**REMARKS**

Claims 1 through 51 are pending; independent claim 25 and its dependent claims 26 and 27 are amended, while independent apparatus claim 51 is newly presented.

5,828,834

## FIG. 3 (Amended)

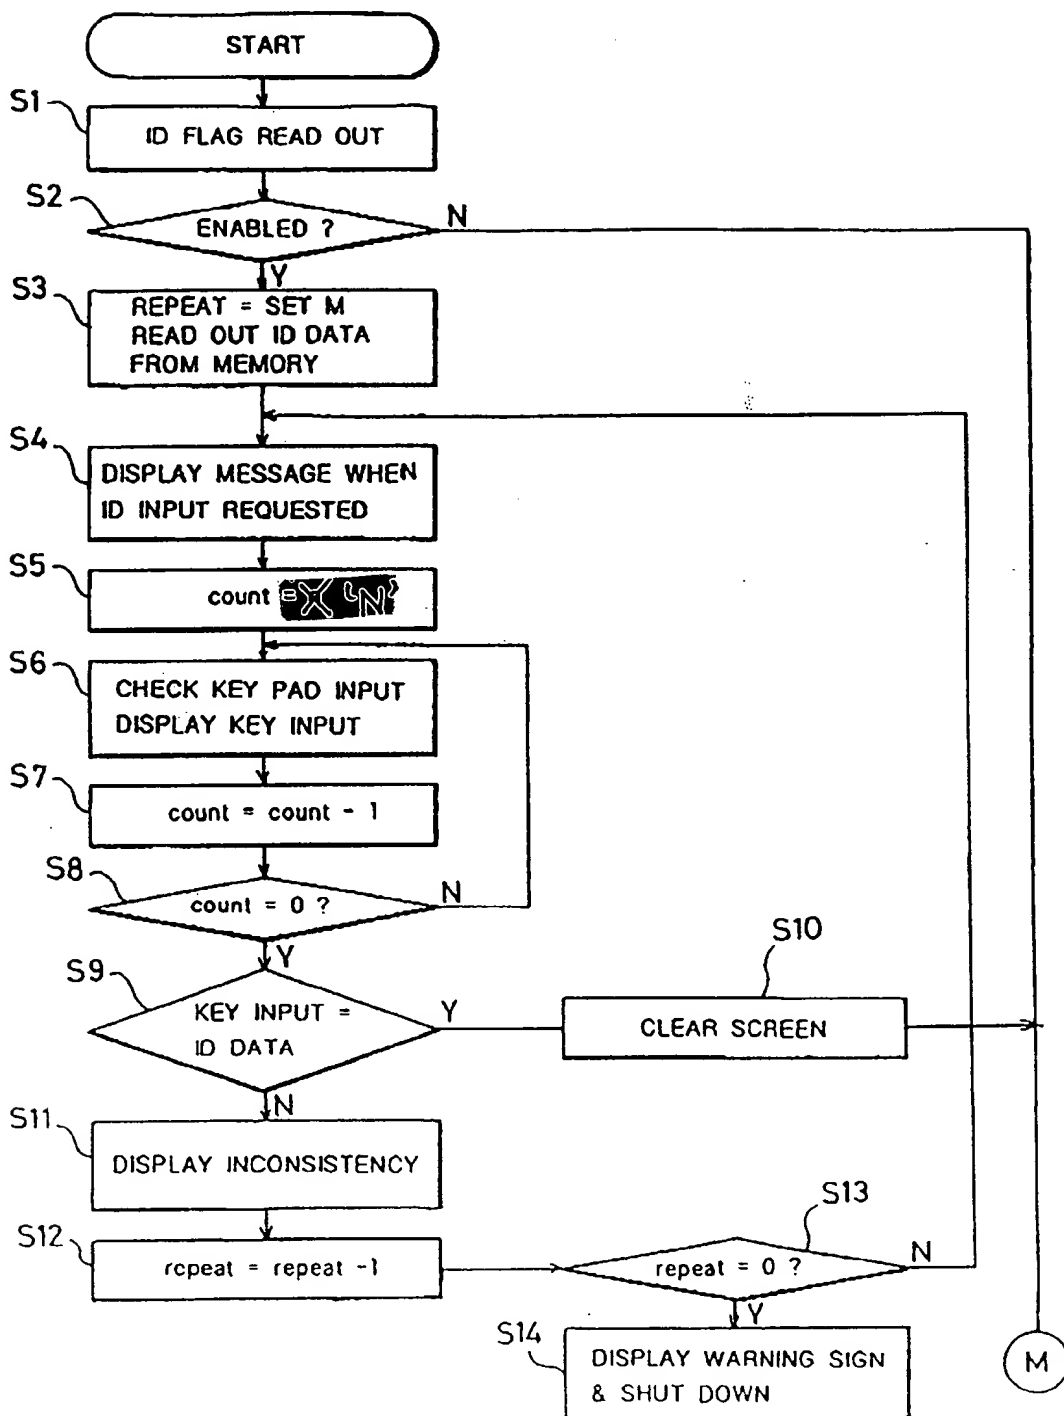
Figures 3, 5(A) and 5(B) are being amended; reference symbol *n* has been amended to '*N*' in block S5 in Figure 3, reference symbol *n* has been amended to '*N*' in block K1, and END has been amended to read "Go To J2" in Figure 5(A), and END has been amended to read "Return to J" in Figure 5(B). Entry of the corrected formal Figures 3, 5(A) and 5(B) is respectfully requested.
